PANAMA CANAL AUTHORITY	VARIATION	PAGE 1 OF 6
1. REQUEST FOR PROPOSAL No.: RFP-76161	2. CONTRACT No.: CMC-221427	3. DATE: June 9, 2011
		4. VARIATION No.: 013 (R)

Variation No. 013 is issued to incorporate the following changes:

Design and Construction of the Third Set of Locks

Figure #1

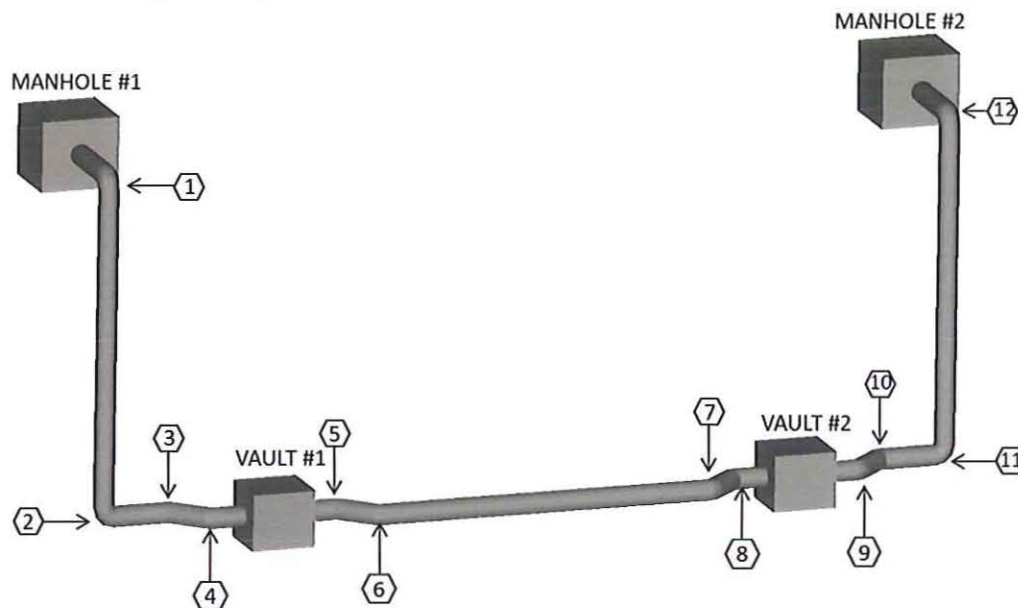
2. **Volume II, Part 1, Section 01 81 29 [Elect. and Lighting Systems]-** Delete Paragraph 1.04 H, and replace it with the following:

"H. Crossunder:

1. The Crossunder tunnel for electrical, control, communication, and power cables shall be separate from the water, air, and oil tunnel. There shall be at least two electrical/control/ communication Crossunder tunnels, one in the higher level and another in the lower level. All cables shall be run in cable trays, except medium voltage cables, which shall run under the floor in concrete encased ducts, with access provided by manholes at both ends of the crossing, or as an alternative as indicated in paragraph 2 below. Cable trays shall be separate and dedicated for power, as well as separate and dedicated for communication and control. Cable tray and hardware support shall be corrosion resistant. Illumination in the tunnels shall be connected to alternate sources and provided with battery operated emergency power source. Tunnels shall be provided with alarm systems to alarm locally, at the control building, and at the guard booth, in the event of flooding condition or loss of forced air ventilation.

2. In lieu of installing the medium voltage cables in concrete encased ducts under the floor with access provided by manholes at both ends of the crossing, the concrete duct banks could be installed in the tunnel as follows.

*a) **Access:** Cable vaults, with a minimum dimension of 3 meter wide, 2.5 meter deep and 2.5 meter high, shall be provided at both end of the crossing for each of the duct banks. Doors shall be hinged or sliding for ease of access to the vault. Ducts banks shall enter at each side wall at midpoint between the front door and back wall. Contractor shall install cables in the conduits of the duct banks located toward the back of the vault and leave the unused conduits (spare) in the front. Ducts shall be provided with end bells. Vaults shall be provided with pulling irons and cable trays.*

*b) **Aisle:** The duct banks shall be arranged so that the walking aisle in the crossunder tunnel has a minimum width of 2.0 meter.*

c) **Conduits Arrangement:** All bends shall be done using manufactured elbows. Elbows shall have a minimum radius of 36 inches.

1) The numbers of conduit bends between the upper manholes and the vaults shall not exceed a maximum of four totaling 270 degrees or less. The elbows next to the manholes shall have a minimum radius of 48 inches (Elbows #1 and #12 in Figure #1).

2) The numbers of conduit bends between vaults shall not exceed a maximum of four totaling 180 degrees or less. The elbows next to the vaults shall have a minimum radius of 48 inches (Elbows #5 and #8 in Figure #1).

Pulling: Each duct bank shall be designed so that the maximum pulling tension shall not exceed 3300 lb when pulling three conductors in a conduit. The sidewall pressure shall be limited to 500 lb/ft for 15 KV conductors and 600 lb/ft for the 44 KV conductors. Calculations shall consider that the pulling is done at the manholes or vaults, a coefficient of friction of 0.35 and that cables are pulled in any direction between Manhole #1 and Vault #1, Vault #1 and Vault #2, Vault #2 and Manhole #2." (RFV 048)
